July 19, 2022

Re: Dimensional Variance for Building Height – 1 Congress Street

Figure 1 – Assigning Building Height Standards on Corner or Through Lots – 1 Congress Street

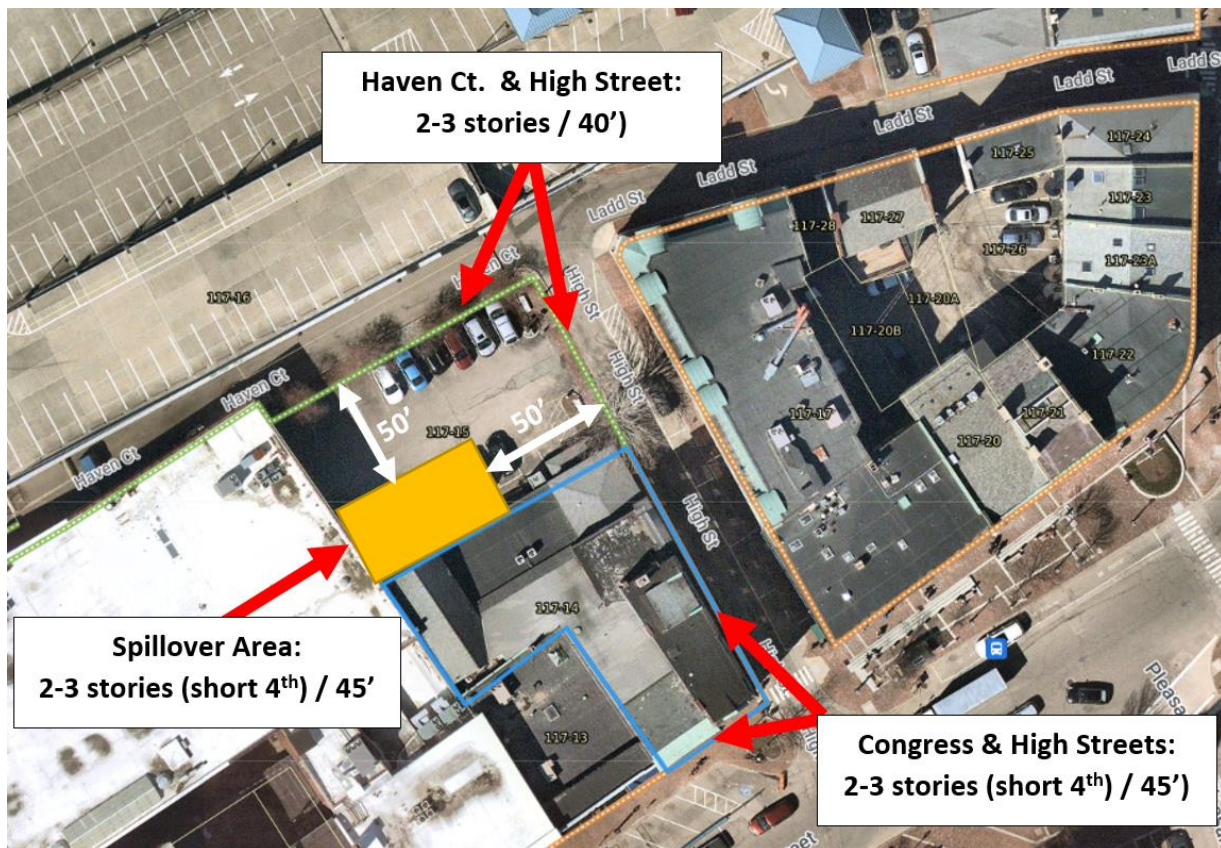
High Street and Haven Court – High Street is considered a public street. Due to city maintenance and public access rights, the City considers Haven Court either a street or a public place. Accordingly, the Zoning Ordinance applies the assigned building height standard to all three sides of the newly merged lot. Figure 1 shows:

- 80% of the assigned building height standard along High Street is 2-3 stories (short 4th) or 45;
- 20% of High Street is designated as 2-3 stories or 40’.

This lower building height was largely derived by the prior ownership structure and the parking lot’s relationship with the Newbury Building and Haven Court. It was also never contemplated that this lot would be merged with 1 Congress Street nor that centralized universal access would be proposed for the both the proposed and historic buildings.
